Public Hearing

CASE SUMMARY SHEET

CASE NUMBER: V26-05-13_R26-05-02

REQUEST: V26-05-13_R26-05-02 – Matthew Frank Costa requests a variance to CLURO Section 7.5.1.3. R-1 Site Development Regulations, and to subdivide lot 4A into lots 4A1 and 4A2, West Beach Parkway, Square 9 Lot 4A, R-1 - Single Family Residential District, Square 9 Lot 4A

RESUBDIVISION OF
LOT 4A * SQ. 9 * WEST BEACH PARKWAY
SECTION 47, TOWNSHIP 8 SOUTH, RANGE 11 EAST
GREENSBURG LAND DISTRICT * CITY OF MANDEVILLE
ST. TAMMANY PARISH, LOUISIANA
INTO
LOTS 4A1 & 4A2

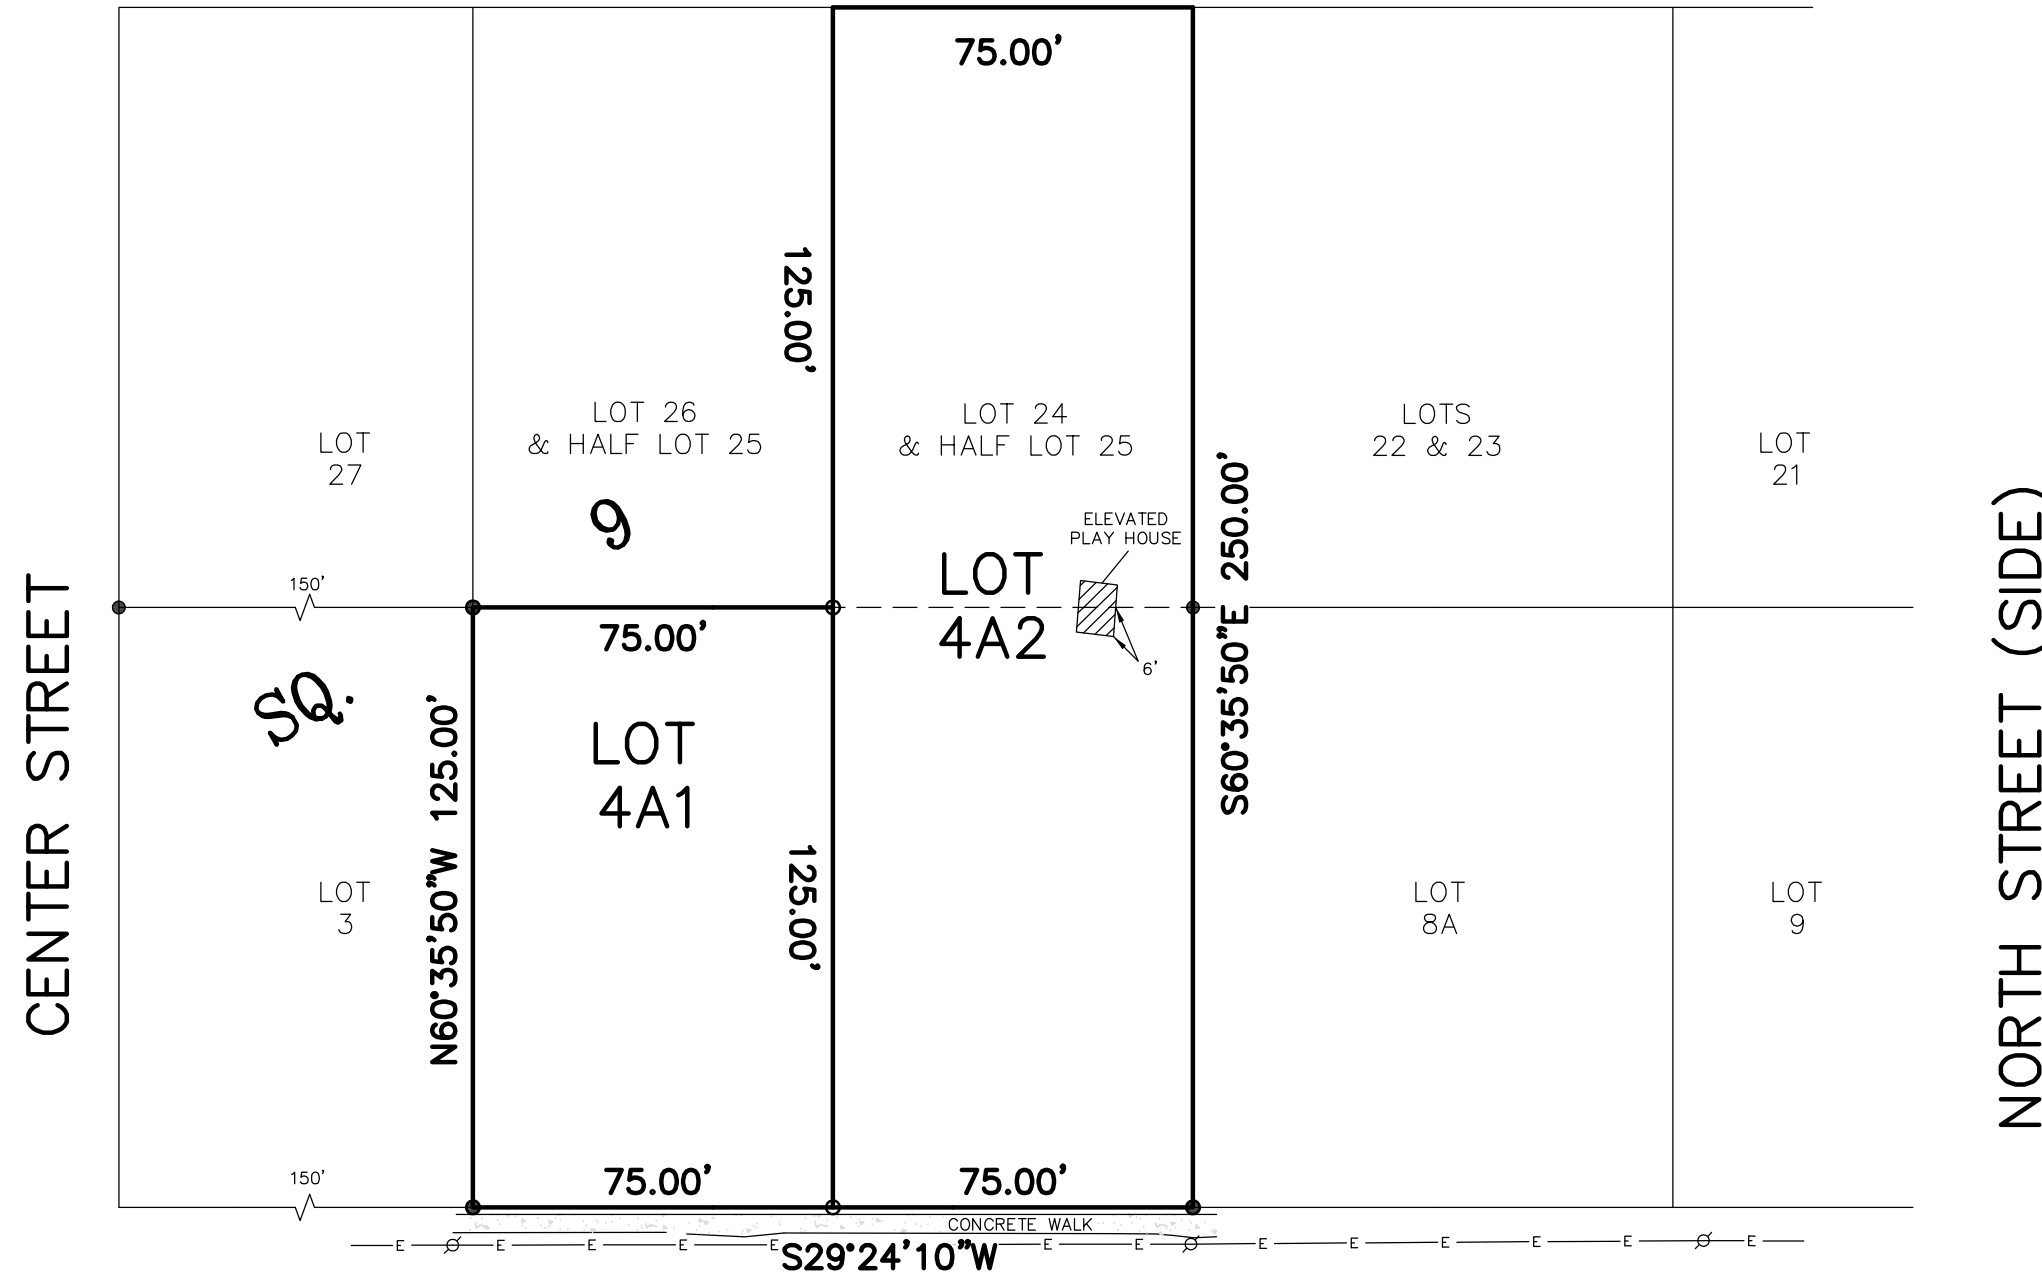
A survey prepared by Randall Brown & Associates, Inc dated 3.17.2026 was submitted. The applicant is requesting to subdivide the parcel into two lots, each measuring 75' x 125'. The proposed lots would be deficient 15' in width and 1,425 sqft in area. Both lots would exceed the depth requirement.

There is an existing accessory structure located on the rear property line of the proposed Lot 4A2. The accessory structure would have to be relocated prior to the resubdivision taking place.

Lot 4A1	Proposed	Required	Difference
Width	75'	90'	-15'
Depth	125'	120'	+5
Area	9,375 sqft	10,800 sqft	-1,425 sqft

Lot 4A2	Proposed	Required	Difference
Width	75'	90'	-15'
Depth	125'	120'	+5
Area	9,375 sqft	10,800 sqft	-1,425 sqft

DRAINAGE AND GRADING PLAN

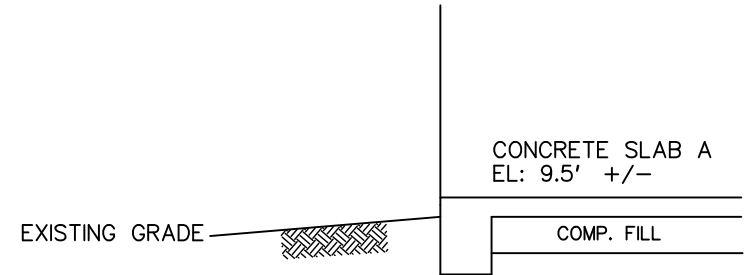
We do not have a drainage plan produced for this building, but I can use information provided from the documents submitted for the permit on the primary structure. The applicant is proposing elevating the slab for the garage to Elevation 11.0 to comply with FEMA regulations. However, Section 5.2.3.3 Fill Sub-Area B 3 Slabs for Non-Habitable Areas only allow “6” inches (0.5’) of height above grade for any other slab”. The average existing elevations within the area of the proposed garage is (8.65’) . Fill Sub Area B would only allow the top of slab to be elevated to (9.15’). The variance request is to elevate the slab to elevation (11.0) a difference of (1.85’) . Additionally, 5.2.3.3 Fill Sub-Area B 1.f. allows for elevating the driveway 6” except within 16’ of the slab to ramp up onto the bottom slab. An additional variance maybe required for the driveway depending on the desired slope to access to building. According to the drainage plan submitted for the primary structure a 1% slope is shown for the driveway approaching the building. If the owner is looking to achieve the same slope the driveway surfacing near the garage would need to be elevated to (10.7’) which would result in fill height for the drive (1.1’) above the allowable (0.5’).

Site Plan - Old Footprint vs New w/ Setbacks

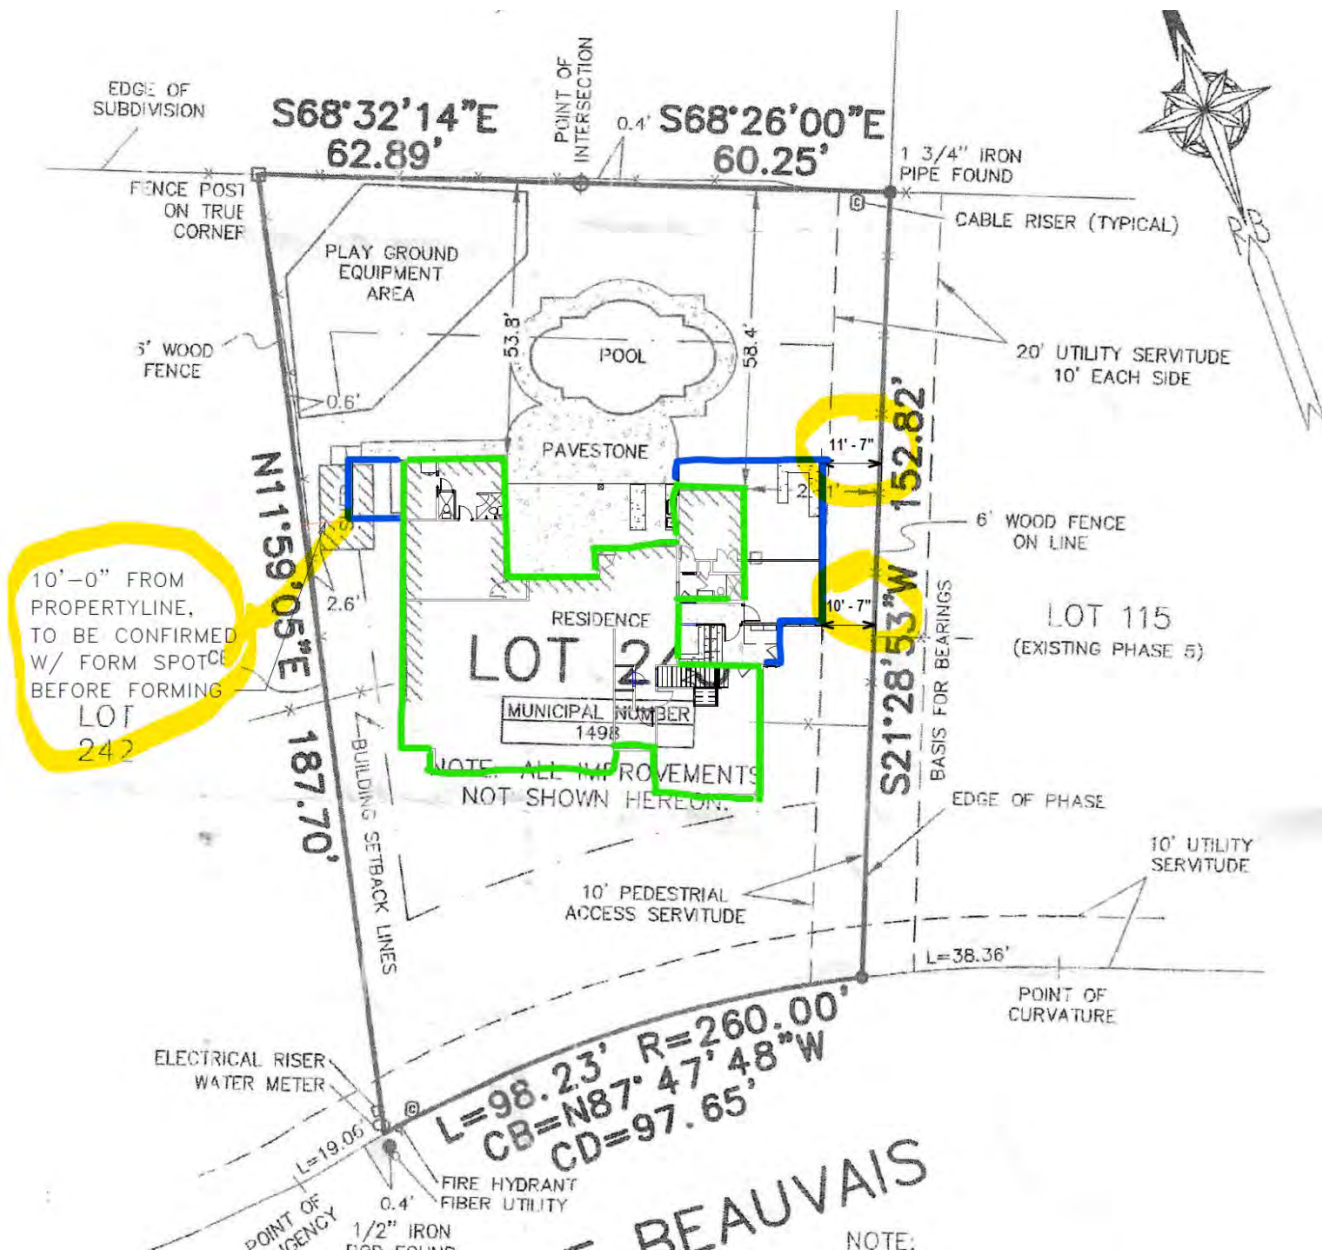
- The existing footprint is outlined in green
- The new addition footprint is outlined in blue
- The new setbacks are circled in yellow
- The entire addition is being added to the rear half of the house, all located behind the gated wooden fence
- Please refer to the separate site plan for mechanical locations
